City of Alexandria, Virginia

MEMORANDUM

FROM: HISTORIC PRESERVATION STAFF

SUBJECT: 220 SOUTH UNION STREET
BAR CASE #2014-0037 and 2013-0321

Figure 1. PREVIOUS three building scheme (L) and CURRENT two building scheme (R)

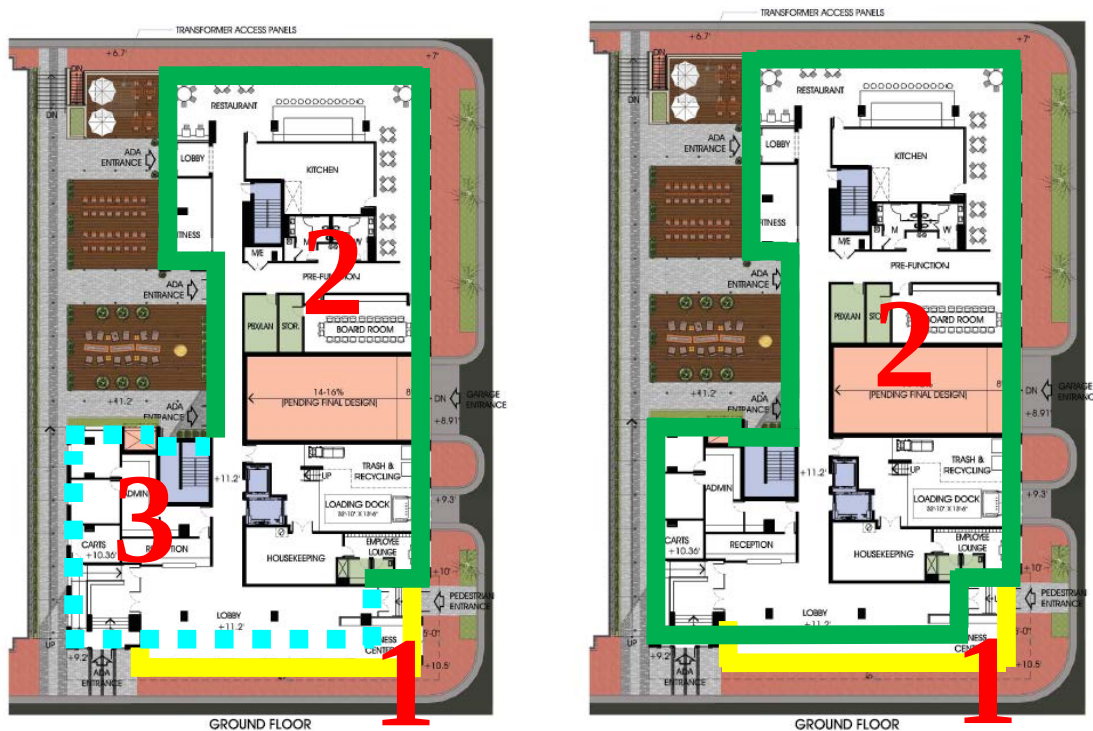
In the continuing effort to simplify the overall design, the project is now a clear two building configuration, as opposed to the previous three building scheme. The design retains the three-story red brick building element on South Union Street and combines what had previously been identified as buildings 2 and 3. Previously, building 3 was not well connected with the overall scheme and it was challenging to reconcile how it fit into the overall scheme. Adding a third brick color for that element resulted in a less harmonious and unnecessarily complex design.

DUKE STREET - WALL SECTION AT MANSARD ROOF

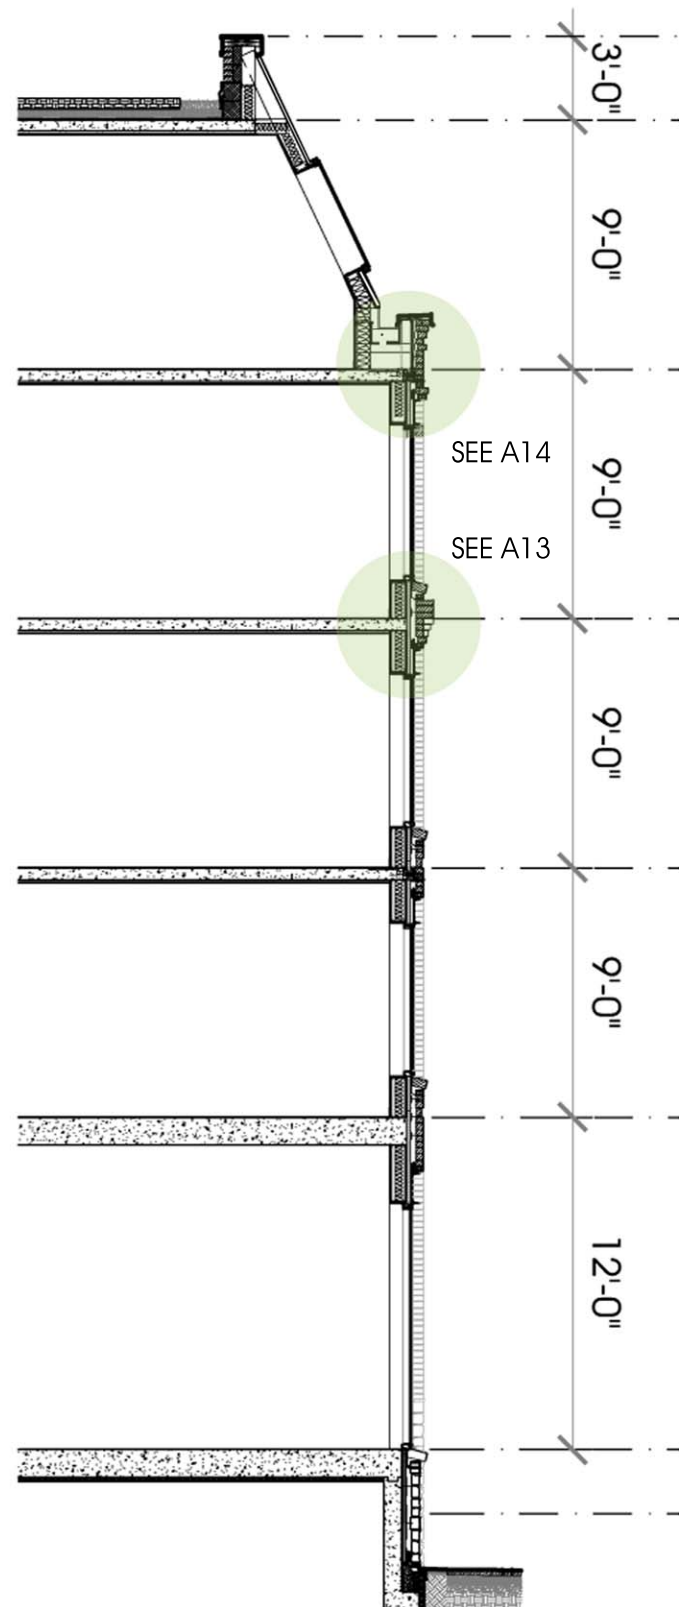
The wall section for Duke Street shows that the pitched roof will clearly be set back from the façade behind a cornice and gutter to allow the building to read as a four-story building with a clearly defined frieze at the 4th story and a pitched roof with shallow roof windows above. The details and sections of the cornice and corbelling indicate a depth and projection consistent with historic elements. Staff is satisfied that these building wall sections and masonry details ensure a well-proportioned, high-quality, appropriately detailed building and recommends approval.

STRAND STREET - WALL SECTION AT "LANTERN"

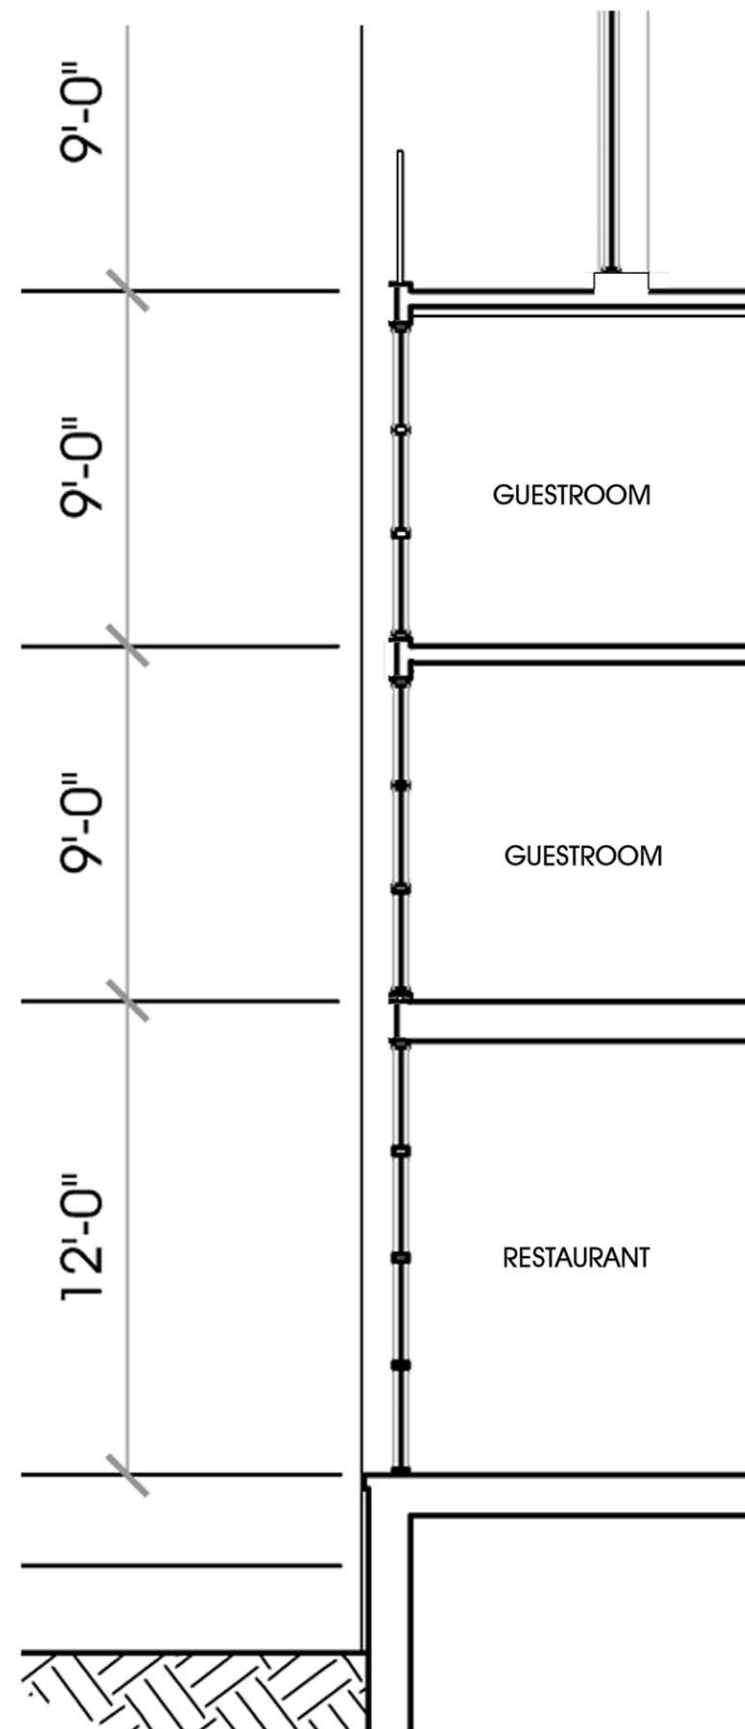
The lanterns have always been envisioned as modern, light-filled elements and have been refined many times. In order to ensure that these elements, some of which are hotel rooms, remain light and transparent, a building section showing that large bulkheads or soffits would not intrude in the space was requested. The applicant explained the building's mechanical and structural systems at the work session and provided a section illustrating that there were no intrusions that would negatively affect the transparency of these elements. The Board accepted the clarification and supported this lantern design.
